Engineering Change Order (ECO)

ECO #: 50244

Title: KCF Compass board new revision

(Figure 1. Mounting of new compass KCF compass module)

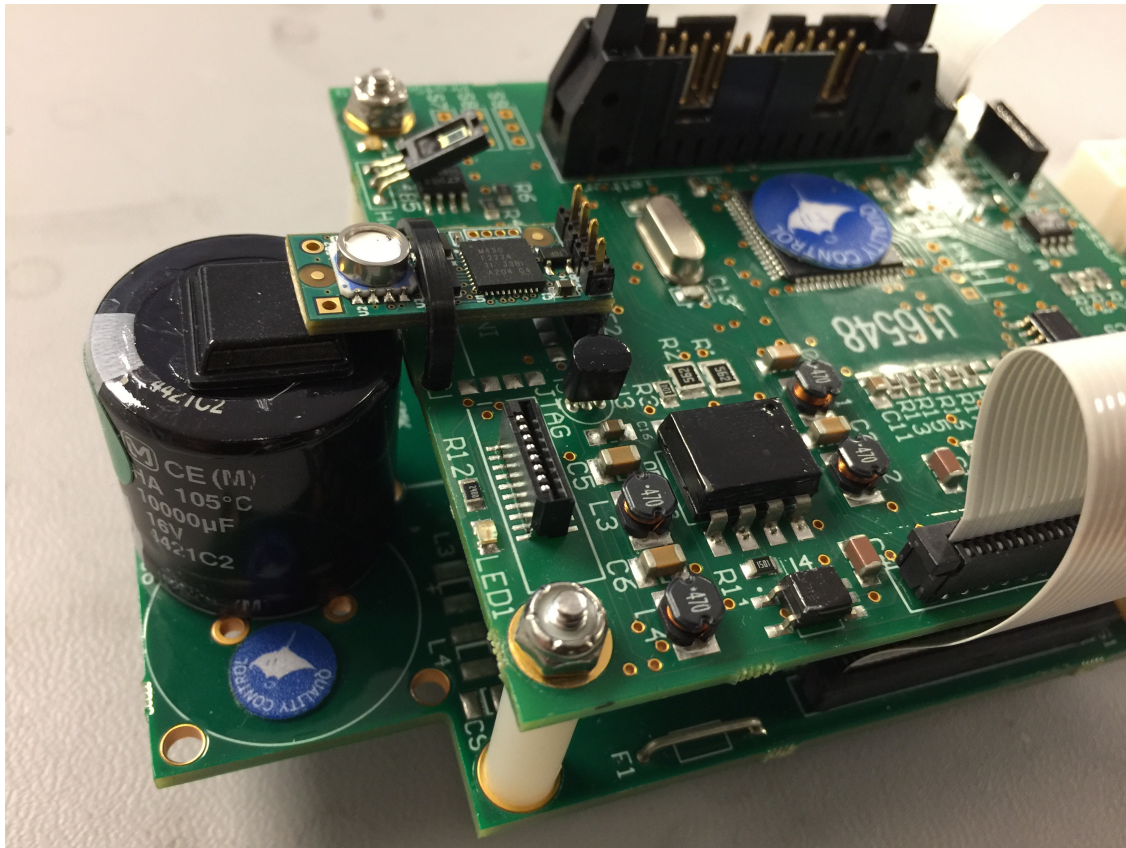
A complete redesign of the KCF module was performed.

It is now smaller, has full 9 DOF, and completely new firmware.

Mounting onto the PRO4 CPU boards remains nearly identical with just minor adjustments for relocating the rubber bumper closer to the compass so the compass can rest on it See figure 1.
